BEECH BOTTOM STORM SEWER LINE UPGRADE PROJECT

ADDENDUM #2

JUNE 23, 2022

THRASHER PROJECT #020-01569

PRO STORM 3 PROFILE

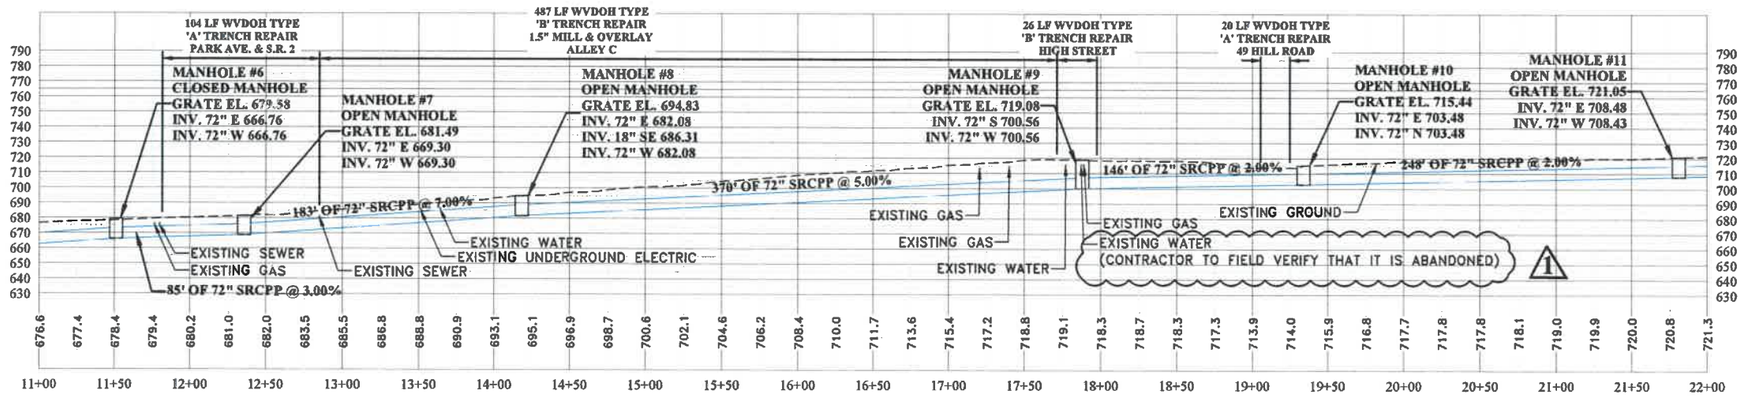
1. Sheet GN1: Revised to add five (5) additional notes pertaining to Traffic Control and storage area.
2. Sheet GN2: Revised notes in the Maintaining Traffic section.
3. Sheet S3: Revised Pro Strom 3 Profile that ties into the Existing Drop Inlet near Basketball Court. Added two notes pertaining to Waterline and Gas Line that runs through manhole No. 9.
4. Sheet S4: Note added to ensure Wingwall No. 4 is at least eight (8) feet away from Edge of Pavement.
5. Sheet D8: Detail addressed to change Trench Detail for 60" to 108" Pipe from an O.D. Min. to an 18" Min.

TRENCH SHOWN IS FOR 60" THRU 108" FLEXIBLE PIPE IN SOIL CUT/FILL SECTIONS

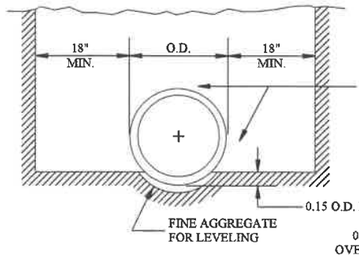
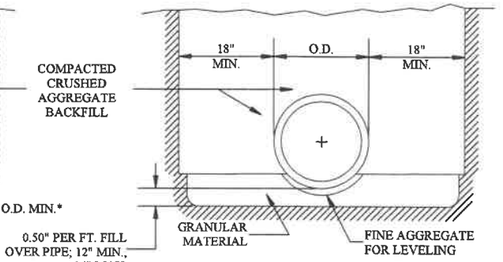
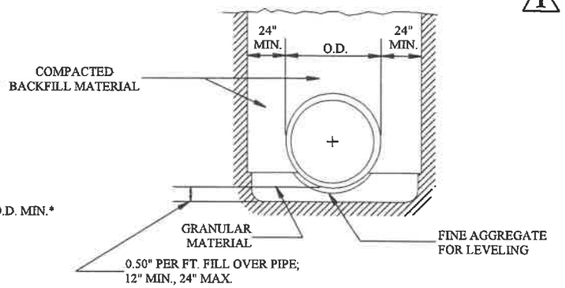
9. With the Trench Detail on Sheet D8 stating that the minimum clear space on each side of the pipe be "O.D. Min.", this will cause a Trench to be approximately 18 feet wide. How will this be accommodated in the alley through town without enough clearance?

Please see Sheet D8 in the plans that properly address this question. A minimum of 18" clearing will be required on each side of the pipe.

WVDOH TYPE "A" TRENCH REPAIR
NOT TO SCALE

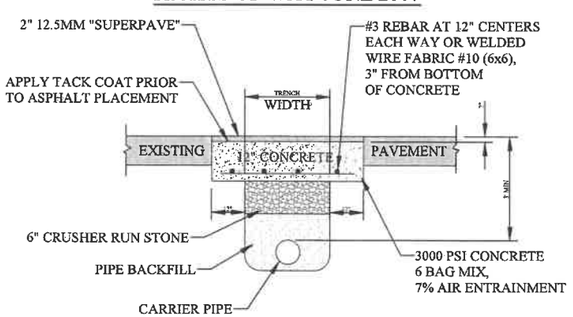
6. Sheet D10: Changes made to the WVDOH Type "A" and Type "B" Trench Repair detail at the request of the WVDOH.
7. Sheet D11: Removal of one (1) of the Resurfacing Heel-In Details that was on the sheet twice.
8. Sheet D14: Was added to show the Traffic Control Plan that was selected and approved by the WVDOG for construction when working on WV-2 and 49 Hill Road.
